**STAFF RECOMMENDATION**  
**1809 Cedar Lane**  
**October 21, 2015**

**Application:** New construction - addition  
**District:** Belmont-Hillsboro Neighborhood Conservation Zoning Overlay  
**Council District:** 18  
**Map and Parcel Number:** 11704032300  
**Applicant:** Nick Dryden, Architect  
**Project Lead:** Sean Alexander, sean.alexander@nashville.gov

<p><b>Description of Project:</b> The applicant proposes to enlarge a contributing house with a ridge raise and rear addition.</p> <p><b>Recommendation Summary:</b> Staff recommends approval of the proposed addition with the condition that staff approves the roof color, masonry, and the selections of windows and doors. Meeting that condition, Staff finds the proposal to meet the design guidelines for additions in the Belmont-Hillsboro Neighborhood Conservation Zoning Overlay.</p>	<p><b>Attachments</b> <b>A:</b> Photographs <b>B:</b> Site Plan <b>D:</b> Elevations</p>
--	--

Exterior Elevations

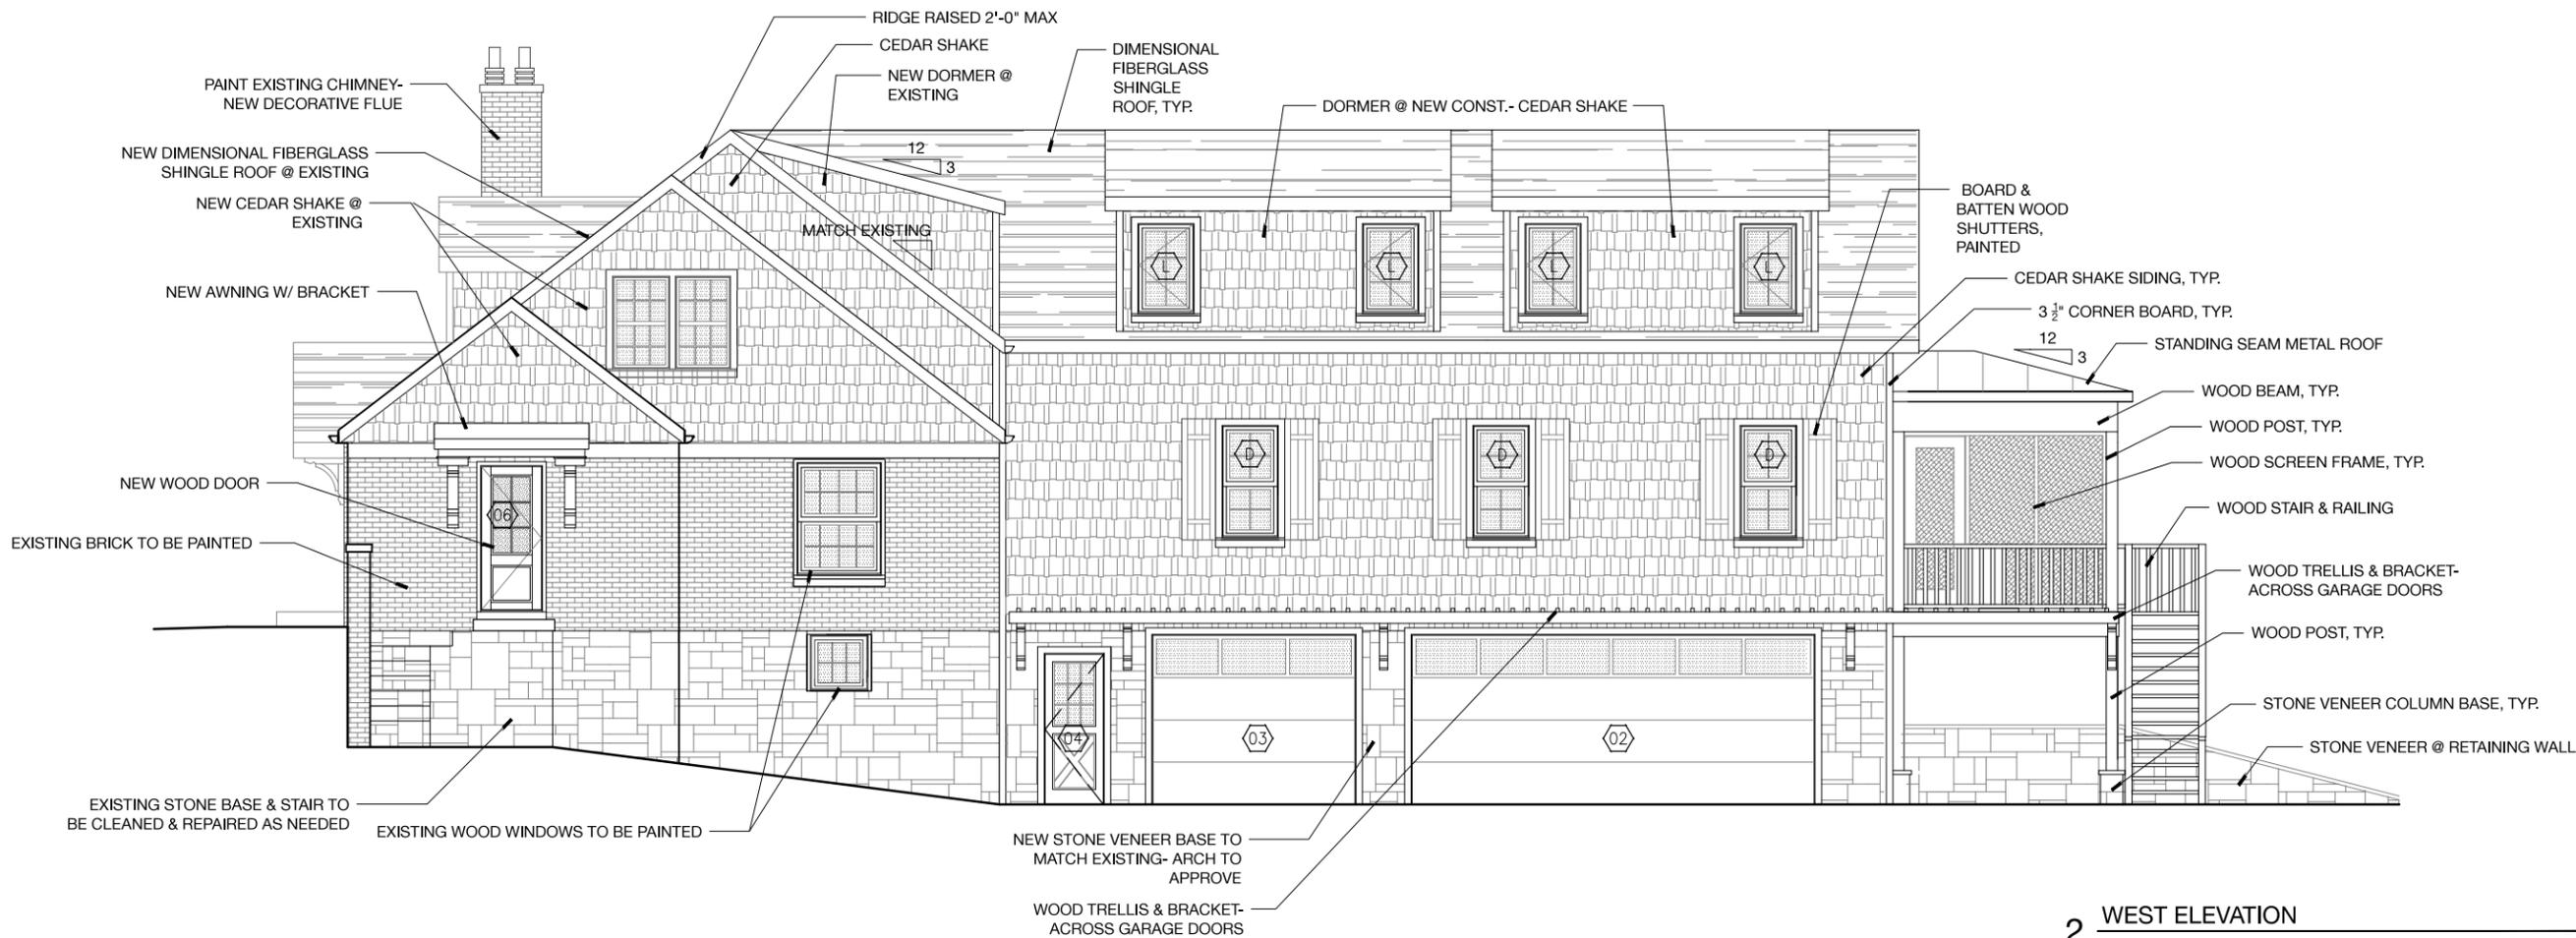
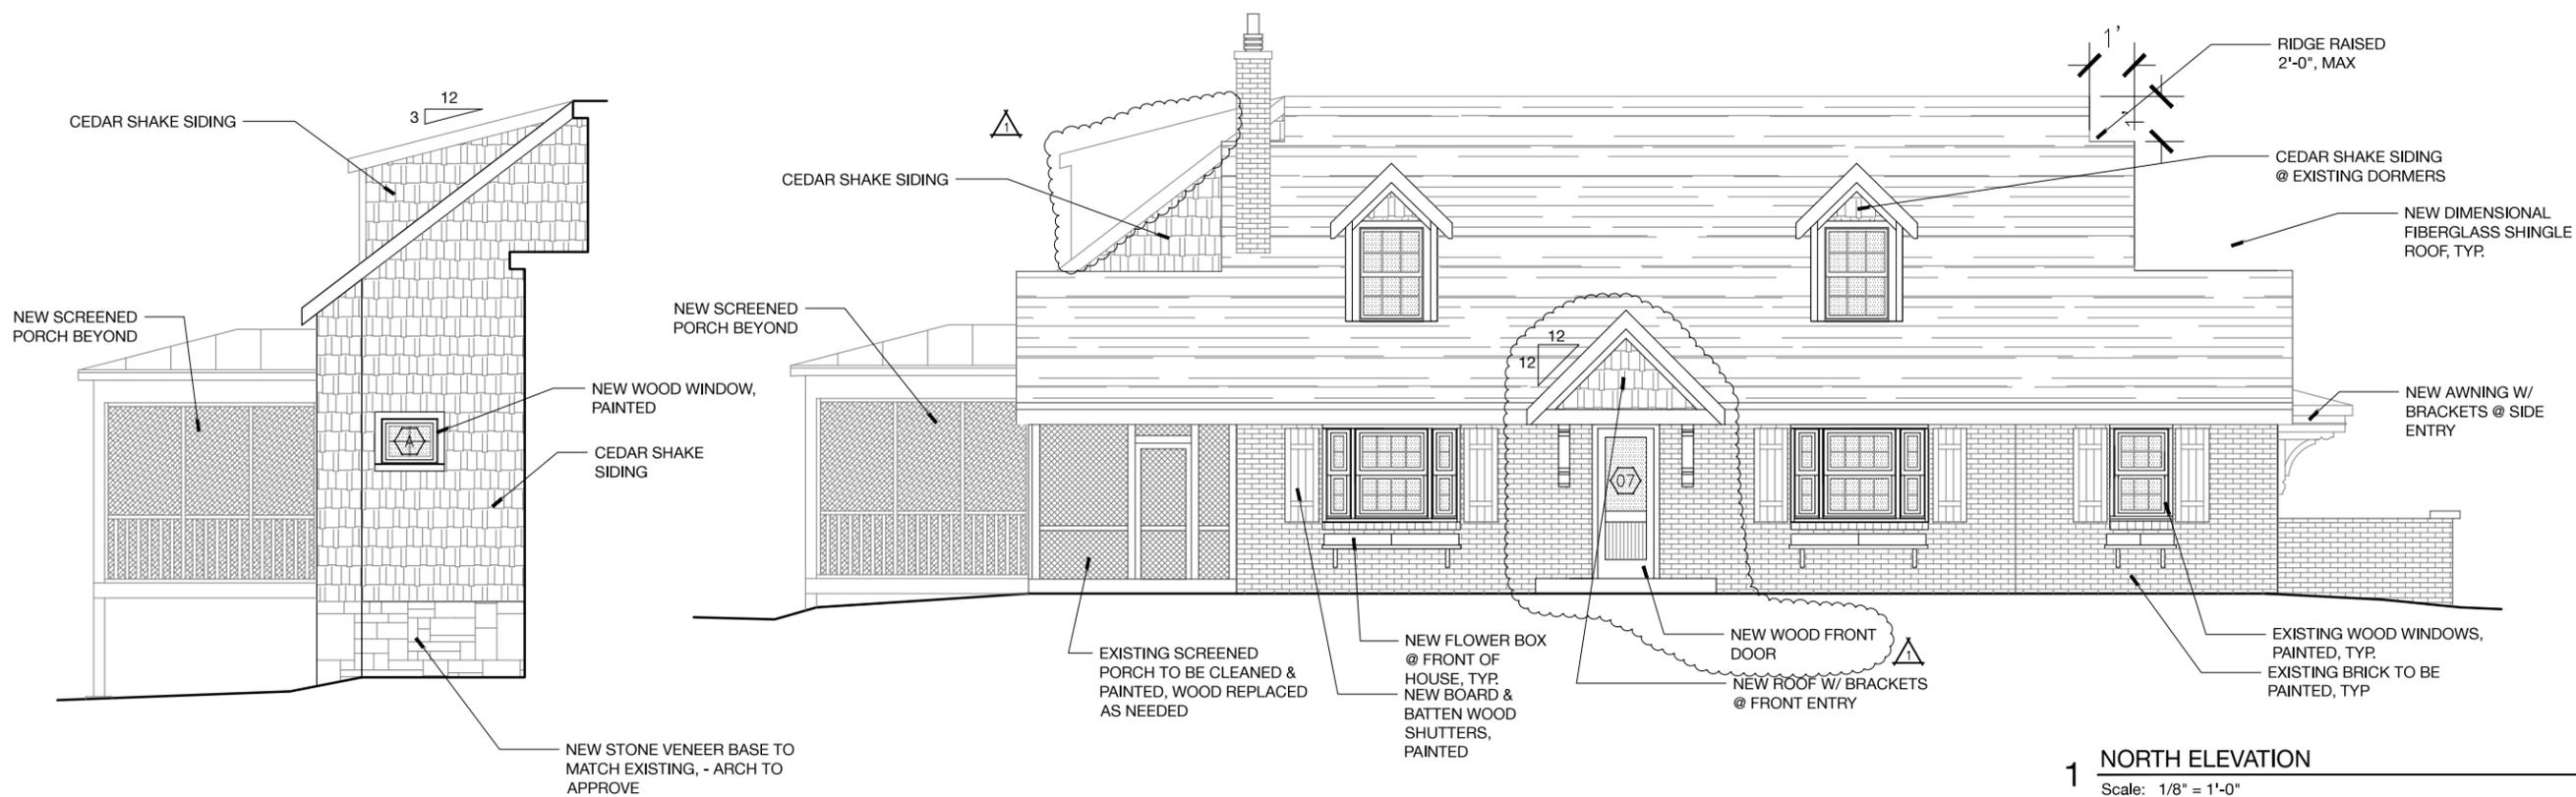
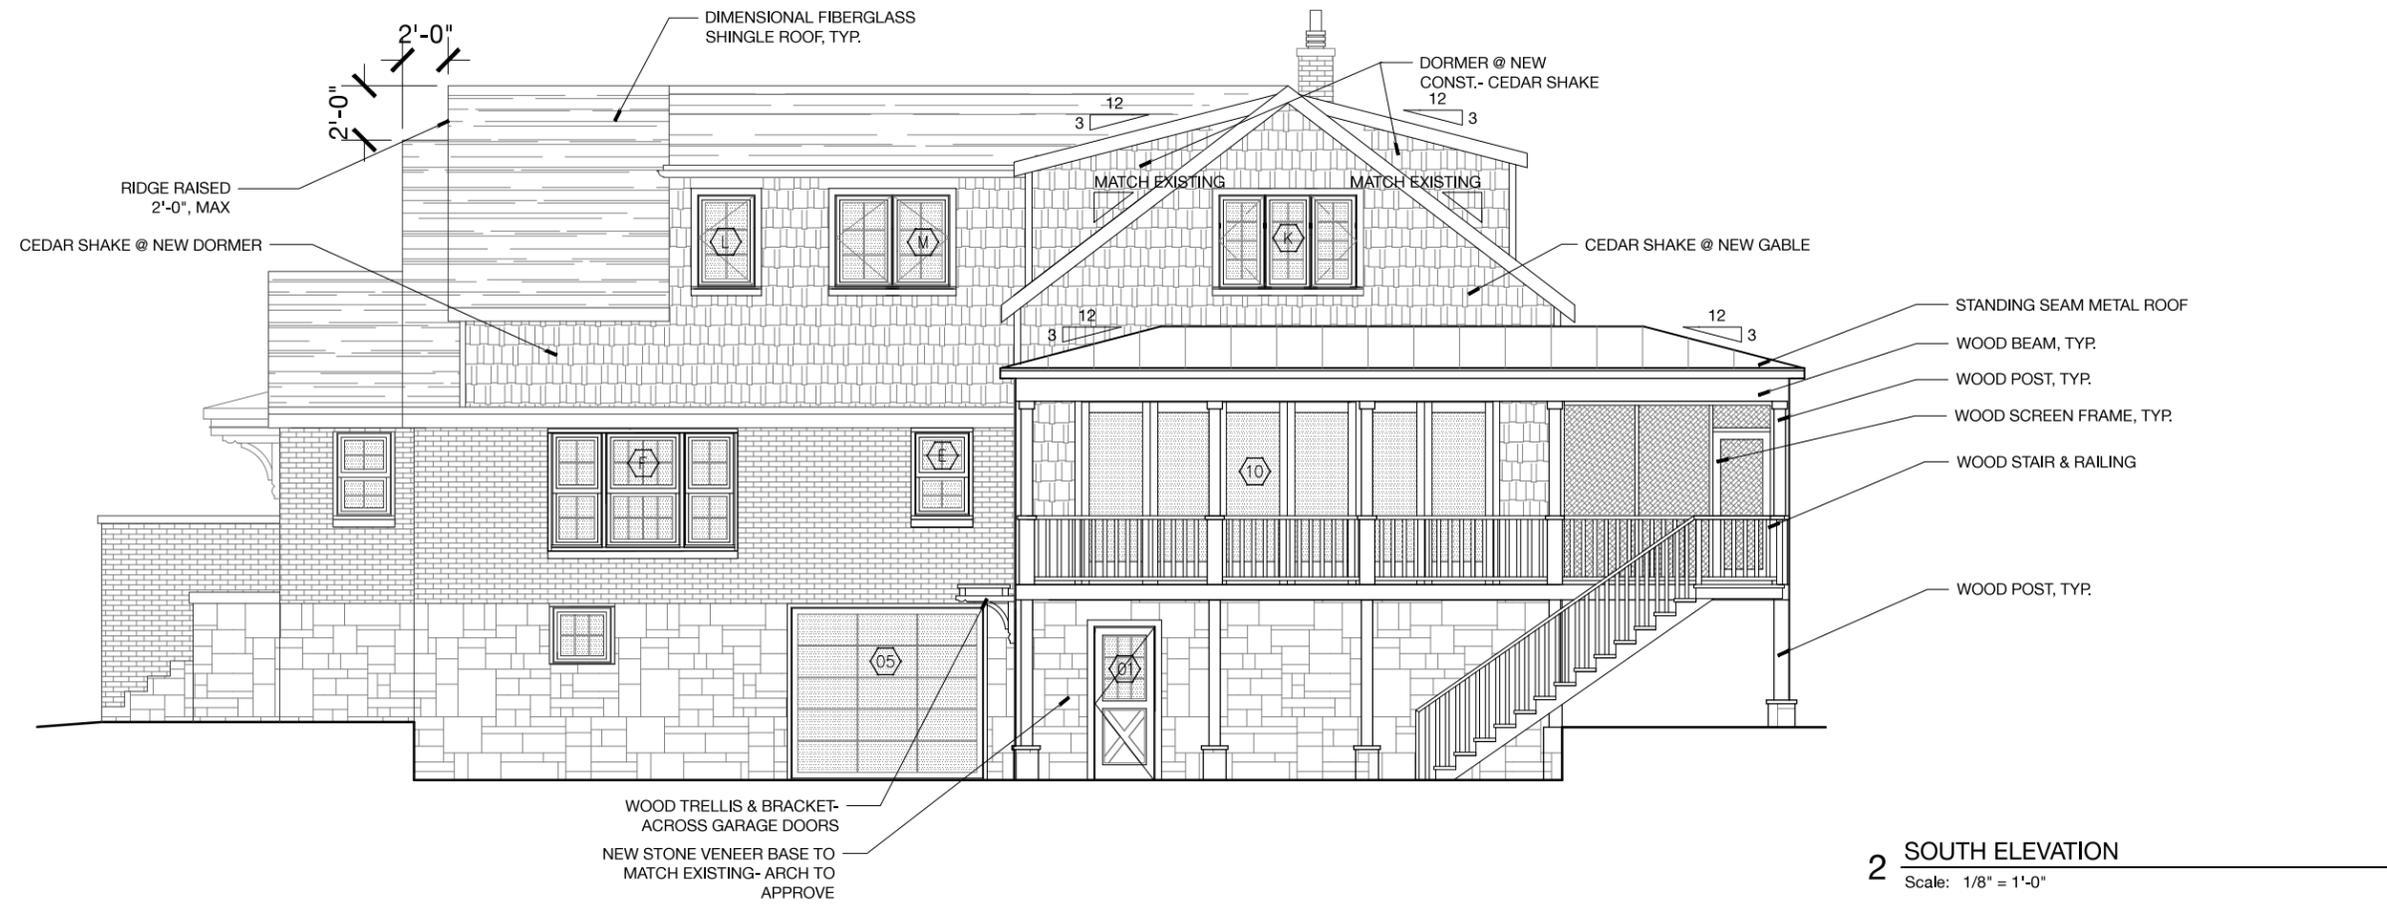
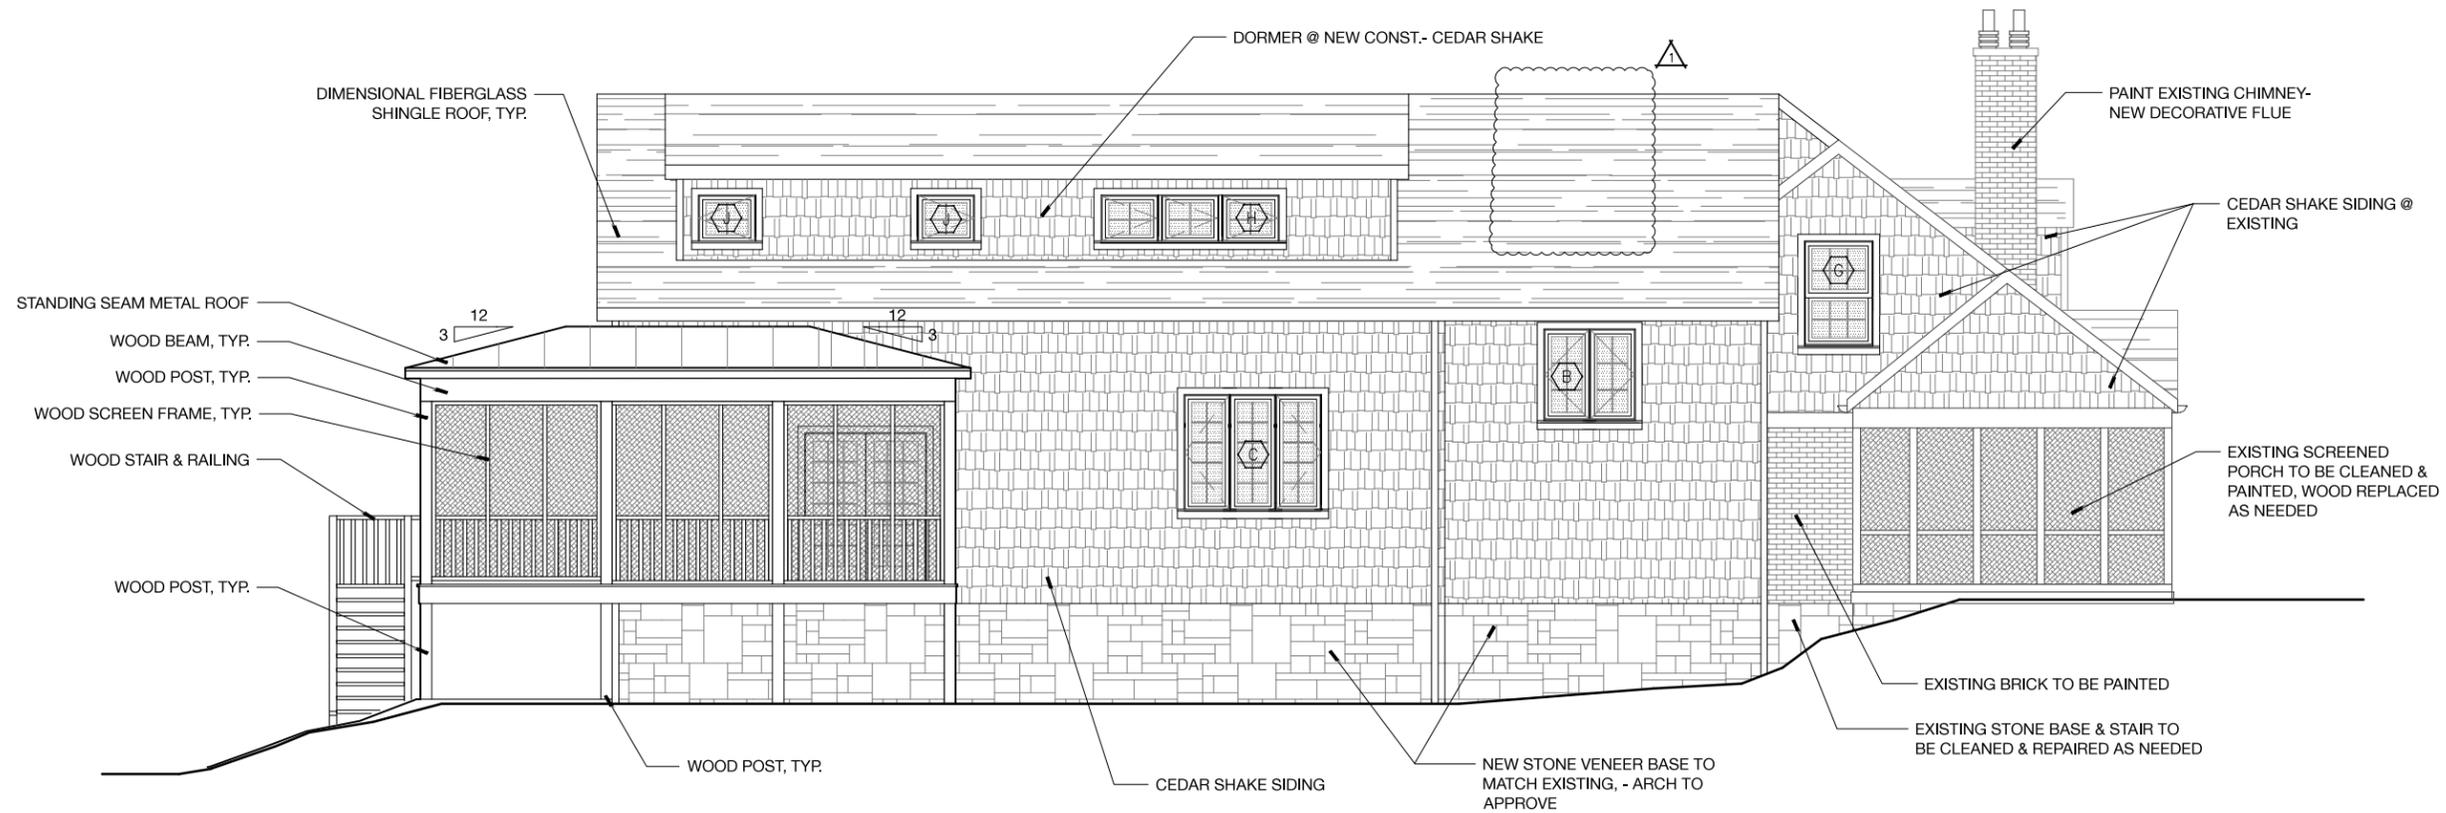
The proposed addition would extend the front slope of the existing roof up and to the rear, creating a ridge two feet (2') higher than the existing ridge. Two feet (2') of the existing roof unaltered on each side to preserve an indication of the original form.

The roof of the addition will tie into the left fascia of the new raised roof, two feet (2') taller than the original roof, with a gable extending from that point toward the rear. By meeting the raised ridge at the far left end, the addition will have a partial gable wall facing the front. Although this wall is only eighteen feet (18') behind the front wall of the house, it will be largely obscured behind the roof of the existing side-gabled porch.

Although the addition will not be fully set behind the house on the left side, it will be clearly distinguishable as an addition by having cedar shingle siding, whereas the original building is brick. The character of the addition will also relate to the historic house by having a matching roof pitch and form, and because the exterior will be clad with compatible materials. Other aspects of the design, including the proportion and rhythm of window openings, will also be compatible.

The new roof will match the 9:12 pitch of the existing gable roof with a 3:12 pitched shed dormer stepped back two feet from the first story wall on the left side as is typical of historic dormers. These roofs are compatible with those of the existing building and surrounding historic houses.

Bracketed awning roofs will be added over the front and right side doors. While front additions are not appropriate, the Commission has approved minimal stoop covering without columns over doors to be added.

The windows on the proposed addition are all generally twice as tall as they are wide, thereby meeting the historic proportions of openings. There are no large expanses of wall space without a window or door opening. Staff finds the project's proportion and rhythm of openings to meet Section II.B.1.g.

Staff recommends approval of the proposed addition with the condition that staff approves the roof color, masonry, and the selections of windows and doors. Meeting that condition, Staff finds the proposal to meet the design guidelines for additions in the Belmont-Hillsboro Neighborhood Conservation Zoning Overlay.
